July 13, 2015

Re: Connect America Fund, WC Docket No. 10-90

Comparing A-CAM Capital Expenditure Estimates to Wire Center-Specific Engineering Data

Figure 1. Distribution of A-CAM Deviations from Engineering Data

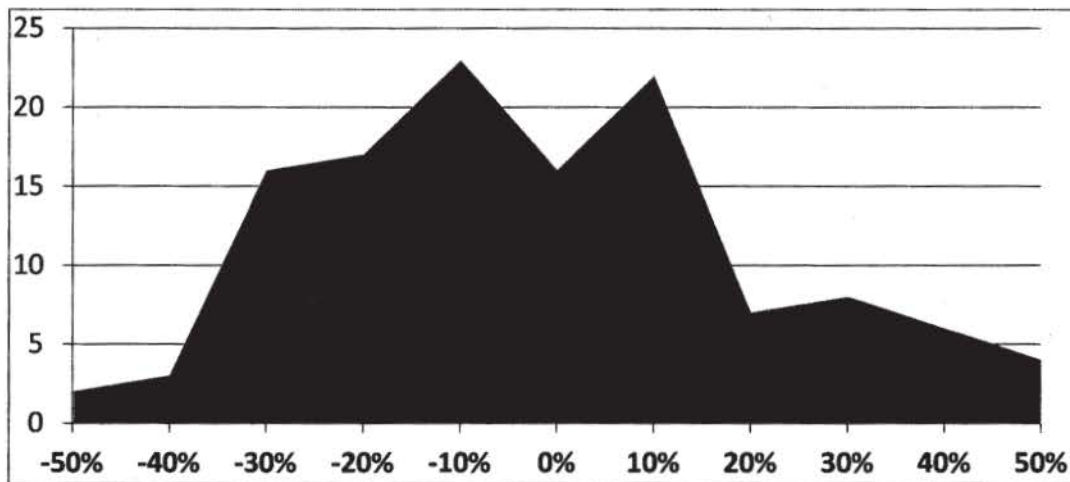
2. **Not all wire centers are average, though.** Looking at mean cost estimates, however, obscures the model's errors. In many cases, the A-CAM estimates deviate substantially from the engineering data, but because the model deviates in both directions equally, estimates that were substantially lower were offset by estimates that were substantially higher. The result is a model that might work well for carriers able to rely on the law of large numbers to "even out" inaccurate high and low estimates across their service territory. Unfortunately, few RLECs have a large enough number of wire centers over which to spread the A-CAM's offsetting errors.

Figure 3. A-CAM Compared to Engineering Data

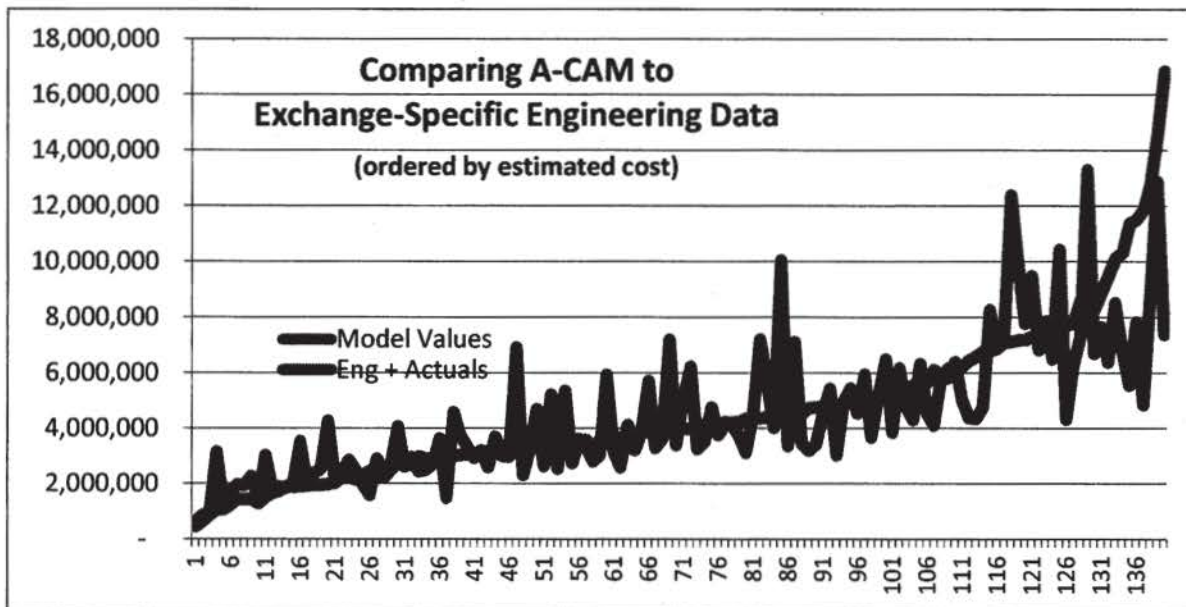
While the other three regions featured a mixture of A-CAM estimates that deviate high and A-CAM estimates that deviate low, the A-CAM capex estimates are consistently lower in the eastern region than engineering data for that region. It appears that the A-CAM doesn't properly estimate costs in that part of the country, but the eastern region featured fewer than a dozen comparisons in the VPS study, so it is difficult to draw conclusions from that sample size. The next section identifies a factor that may be impacting A-CAM estimates for LECs in the eastern region.
